DEC 5 1951  
Ref. Symbol: 1531  
Project No. ST-400

MR. L. E. LAMKIN - 1281  
Re: Tensile Test of H-67 Latch

The object of the test was to pull the latch (made according to Drawing SK (1281) 8650) parallel to the major axis of the latch assembly and determine the amount of separation between the top bracket and the lower portion of the latch.

FIG. 1 - LATCH ASSEMBLY FOR H-67

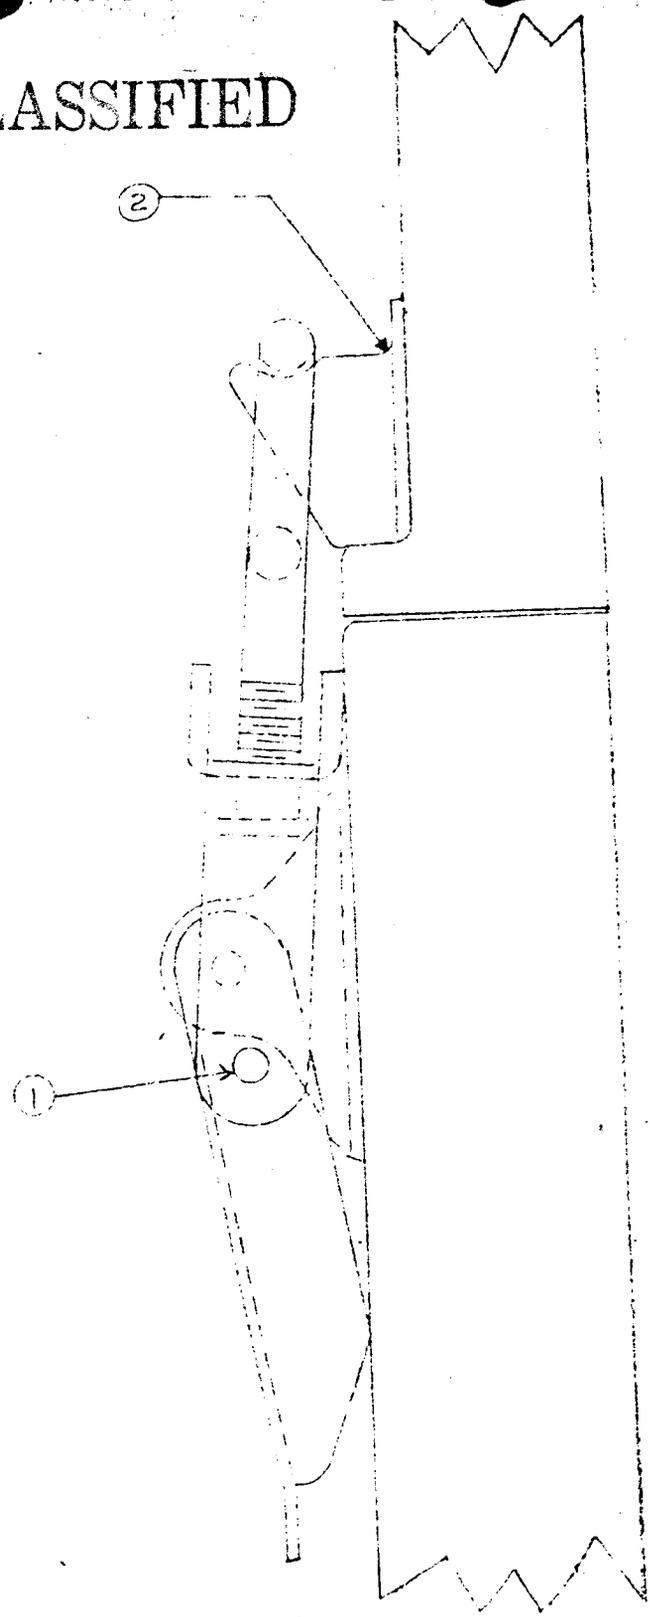
The top section (hook) of the latch broke in the weld under a load of 675 pounds; the top and bottom sections had separated 0.194 inch.

The top latch bracket failed in the weld (No. 2 in Figure 1) under a load of 675 pounds. However, prior to failure a considerable amount of separation

occurred between the upper and lower sections of the latch assembly, as shown in the tabulated data below. The separation was primarily caused by the bending of an aluminum rivet (No. 1 on Fig. 1) in the lower section of the latch assembly.

Division 1531 recommends that a heavier weld be used in fabricating the upper latch assembly. It is also recommended that the rivets in the lower latch assembly be made larger in diameter or of stronger material.
